ADDENDUM 02

WVARNG

BUCKHANNON

AFRC

10 ANSUL SYSTEM INTERCONNECT WIRING DIAGRAM
E5.1 NOT TO SCALE

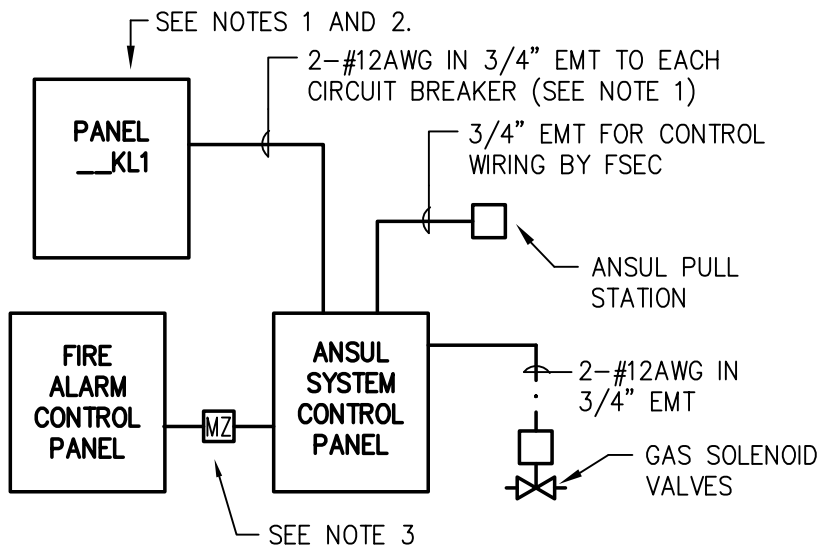
1. PROVIDE SHUNT TRIP BREAKERS FOR ALL ITEMS UNDER HOODS.
2. CONNECT TO SHUNT TRIP CIRCUIT BREAKERS IN PANELBOARD(S) __KL1.
3. PROVIDE ADDRESSABLE MONITORING MODULE FOR EACH ANSUL SYSTEM CONTROL PANEL FOR CONNECTION TO BUILDING FIRE ALARM SYSTEM.

11 AREA OF REFUGE RISER DIAGRAM
E5.1 NOT TO SCALE

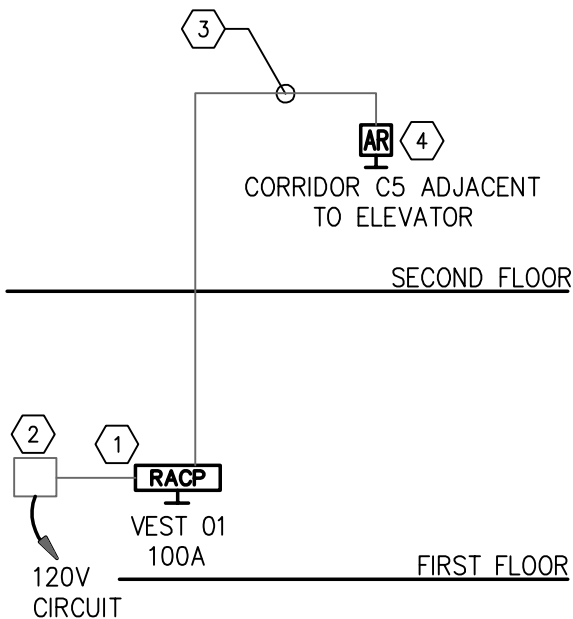
- ① AREA OF REFUGE ANNUNCIATOR WITH 4-ZONES AS SHOWN FOR CALL STATIONS – CORNELL MODEL NO. A4228 OR APPROVED EQUIVALENT. MOUNT 48" AFF TO TOP OF BOX. FACTORY SHALL LABEL EACH ZONE AS DESCRIBED ON THIS RISER. RECESS ANNUNCIATOR IN WALL. PROVIDE ANNUNCIATOR WITH TELEPHONE ACCESS KIT, TAK4200 OR EQUAL, FOR AUTO-DIALER FUNCTIONALITY.

- ② BATTERY BACK-UP / POWER SUPPLY FOR AREA OF REFUGE ANNUNCIATOR CORNELL MODEL NO. C5243 OR APPROVED EQUIVALENT. SURFACE MOUNT ABOVE THE FINISHED CEILING IN VESTIBULE. PROVIDE 18AWG, 2 CONDUCTOR WIRING BETWEEN BATTERY BACK-UP AND ANNUNCIATOR AND CONCEAL WIRING IN WALL.

- ③ WIRING FROM AREA OF REFUGE CALL STATION TO ANNUNCIATOR SHALL BE 22AWG, 4 CONDUCTOR PLENUM RATED WIRING IN 3/4". ROUTE WIRING CONCEALED.
- ④ AREA OF REFUGE CALL STATION WITH INSTRUCTIONS FOR USE OF COMMUNICATOR – CORNELL MODEL NO. 4201B OR APPROVED EQUIVALENT, MOUNT 48" AFF TO TOP OF BOX. RECESS CALL STATION IN WALL.
